<b>Subject:</b>  <b>FRONT BRAKE CREAKING AT LOW SPEEDS</b>	<b>Bulletin No:</b> 04-001/09
	<b>Last Issued:</b> 2/12/2009

2006-2007 MX-5 with VINs before JM1 NC\*\*\*\* \*\* 131172 (built before November 10, 2006)

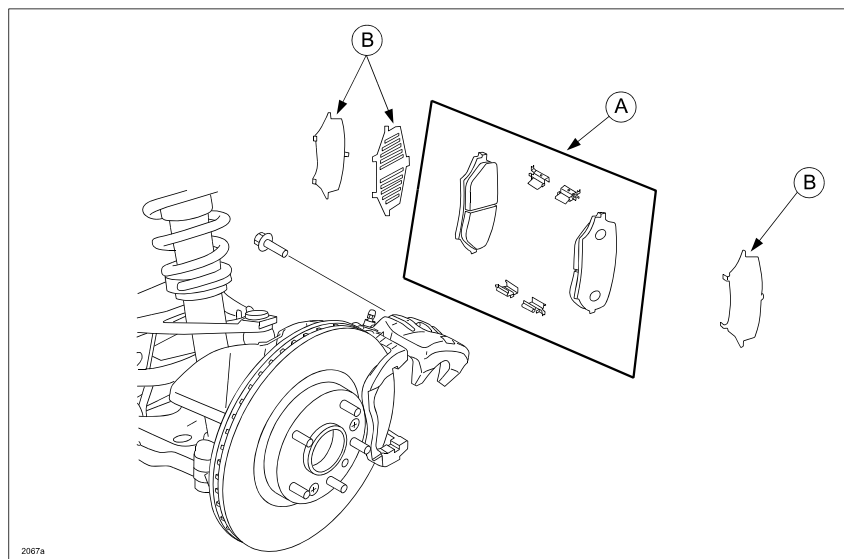
Some vehicles may exhibit a creaking noise when the brake pedal is gently depressed while driving at low speeds. The creaking noise is due to resonance of the front brake pad guide plate. The thickness of the guide plates have been increased to correct this concern.

1. Verify customer concern.
2. Replace front caliper pad sub set with modified parts (A). Refer to MS3 online service information or Workshop Manual section 04-11 DISC PAD (FRONT) REPLACEMENT. Reuse the existing attachment plates (shims) (B) when installing the modified parts.
